Office Action Summary	Application No. 10/692,613	Applicant(s) FRANCIS ET AL.	
	Examiner Sara Addisu	Art Unit 3722

DETAILED ACTION

1. This Office Action is in response to the amendment filed 2/14/06. Claims 18-23 and 26-45 have been cancelled. Currently, claims 17, 24, 25 and 46-49 are pending in this application.

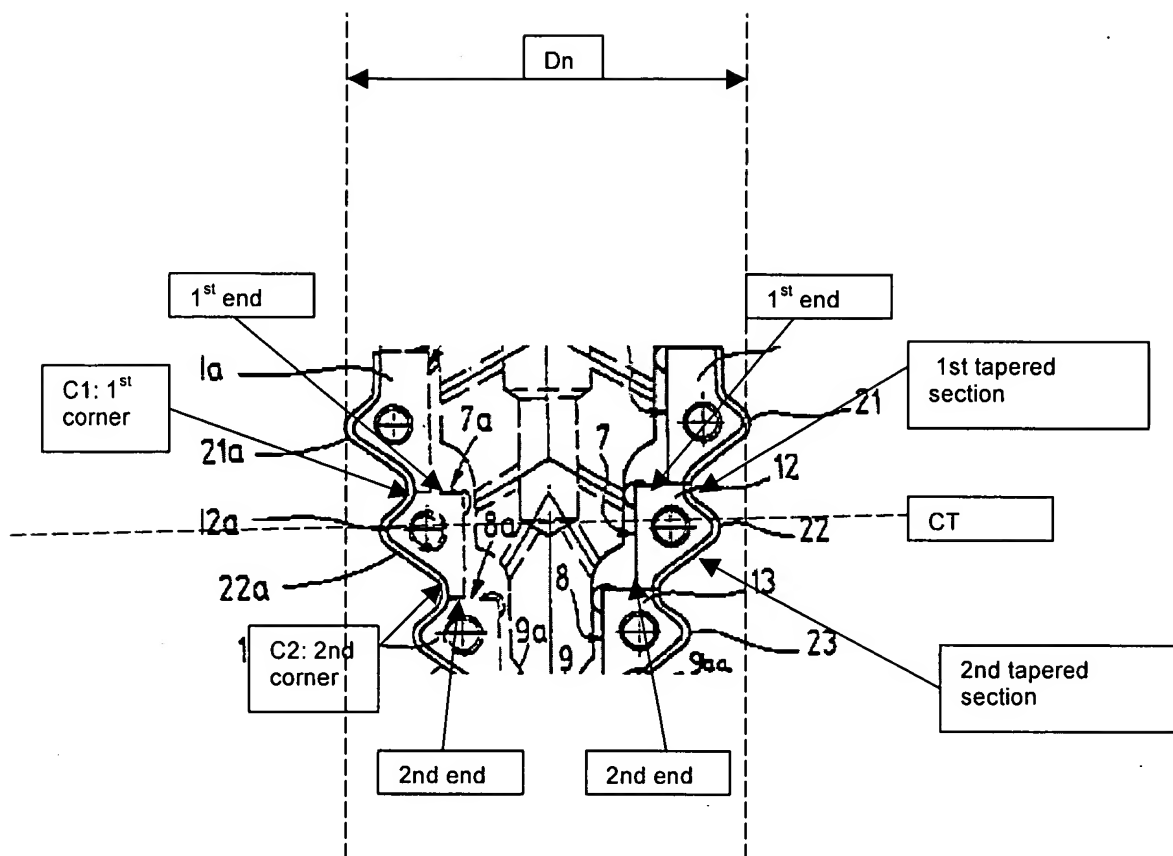
4. Claims 17, 24, 25, 46 and 48 are rejected under 35 U.S.C. 102(b) as being anticipated by Wetli et al. (USP 6,322,296), or, in the alternative, under 35 U.S.C. 103(a) as obvious over Wetli et al. (USP 6,322,296).

Regarding claim 17, WETLI ET AL. teaches a rotary cutting tool (1) including a body (2) having first and second flutes (4,5) including a first and second insert receiving pockets with first and second inserts (12, 12a, respectively) mounted in them ('296, figures 2 and 5). WETLI ET AL. also teaches each cutting insert (12, 12a) having a first end, a second end, a centerline (CT) disposed midway between the first and second ends, a tapered cutting edge (22, 22a) spanning between the first and the second end, a first corner (c1) formed at the juncture of the tapered cutting edge and the first end and a second corner (c2) formed at the juncture of the tapered cutting edge and the second end (see figure below). Additionally, WETLI ET AL. teaches the tapered cutting edges (22, 22a) of the insert being defined by a first and second tapered section, forming a convex curve configuration of a constant radius defining a highpoint there between (see figure below). Regarding claims 24 and 25, WETLI ET AL. teaches helically arranged insert receiving pockets and flutes ('296, Col. 3, lines 3-5 and Col 7, lines 24-29). WETLI ET AL. also teaches a nominal cutting diameter (Dn: see below) and the first and second corners of each insert lie within the nominal cutting diameter

(Dn) when the tool is rotated. Regarding claims 46 and 48, it is inherent that as basic manufacturing practice, tools have a predetermined dimensional tolerance (also admitted by Applicant on Page 5, lines 29-30) and the tolerances are set such that the tool stays within the set tolerance to ensure that discrepancies and poor workmanship are not introduced. Therefore, it is inherent that WETLI ET AL.'s tool has a predetermined dimensional tolerance and the radial runout compensation dimension of the insert would have to be greater than the predetermined dimensional tolerance in order for it to function/cut properly. It is also inherent the maximum outward radial displacement of the inserts' corners are less than the predetermined dimensional tolerance. Furthermore, reading claims 46 and 48 broadly, WETLI ET AL. reads on the claims since the claims do not define what the manufacturing tolerance is.
